**RE: Phase II Remedial Investigation/Feasibility Study Work Plan Addendum
Former National Rubber Adhesives Site
Site No. 2-41-028**

PROJECT TITLE:
**FORMER NATIONAL RUBBER ADHESIVES
38-25 9TH STREET
LONG ISLAND CITY, NEW YORK**

DESCRIPTION:
**REMEDIAL INVESTIGATION
ADDENDUM**

DRAWING TITLE:
**SUPPLEMENTAL
AIR SAMPLE
LOCATION MAP**

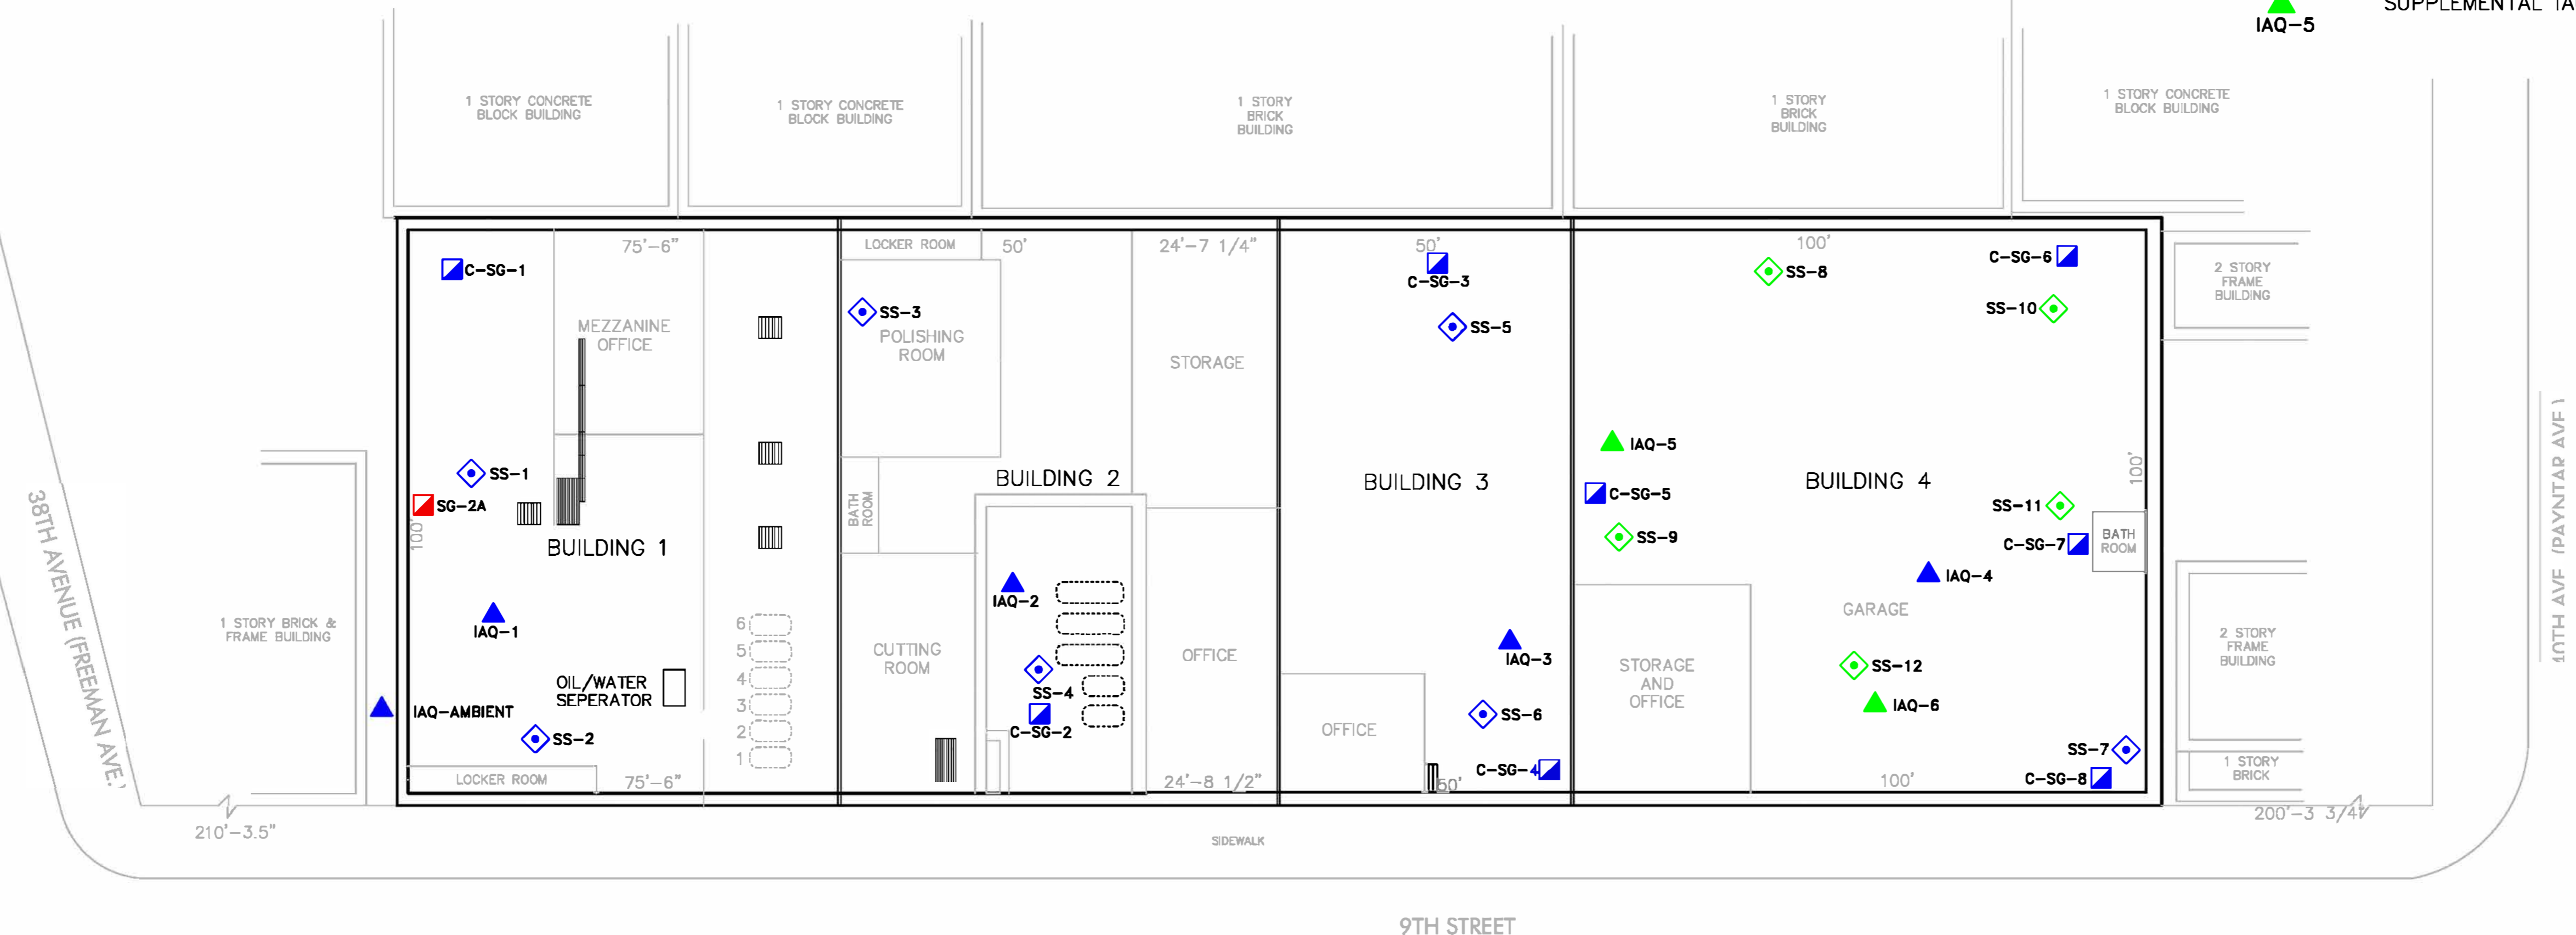
CORE will install an additional five sub-slab vapor points (SS-8 through SS-12) in Building 4 in locations that will provide a more comprehensive data set. Sub-slab vapor samples will be collected from the five newly installed points plus existing sub-slab vapor point SS-7. Two IAQ samples will be collected in addition to previously collected IAQ-4. Air sample locations are presented on the attached Figure 1.
